ADDENDUM #3

RFQ# 7598728

TITLE: REGULAR CAB PLATFORM TRUCK

Page 3 of 15 **TOOL BOXES**

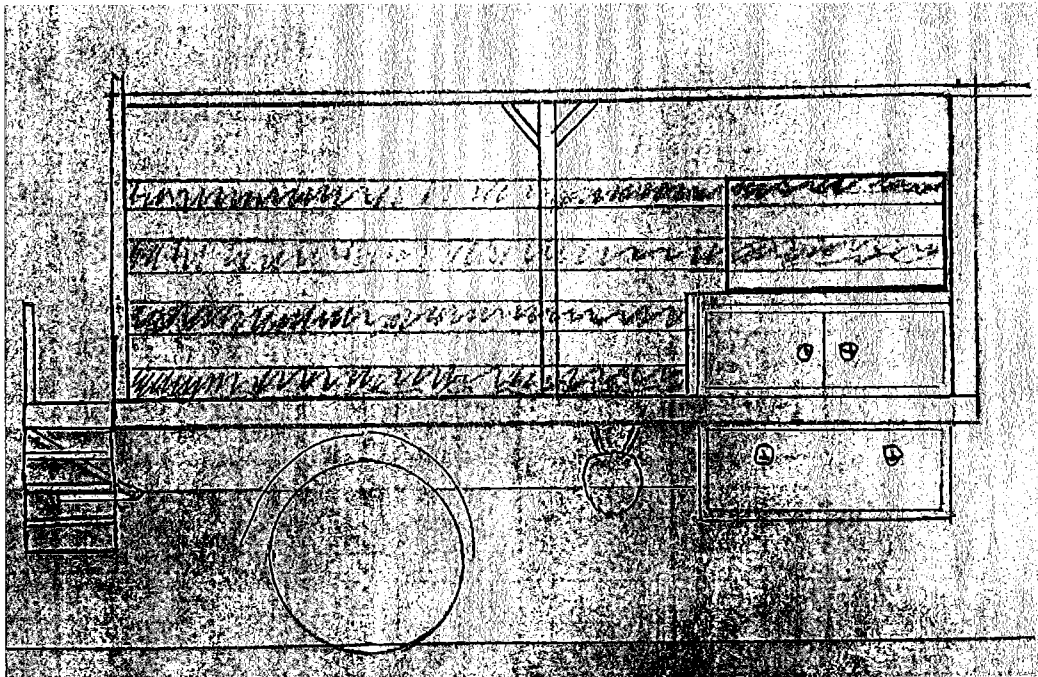
Can you provide any more details on the tool boxes and water tank?

Below is a sketch of the proposed layout of the tool boxes with the water tank installed on top of the cross-bed box. Final placement of these components shall be discussed and approved by RIDOT Motor Pool at a prebuild meeting once all the components are received by to upfitter.
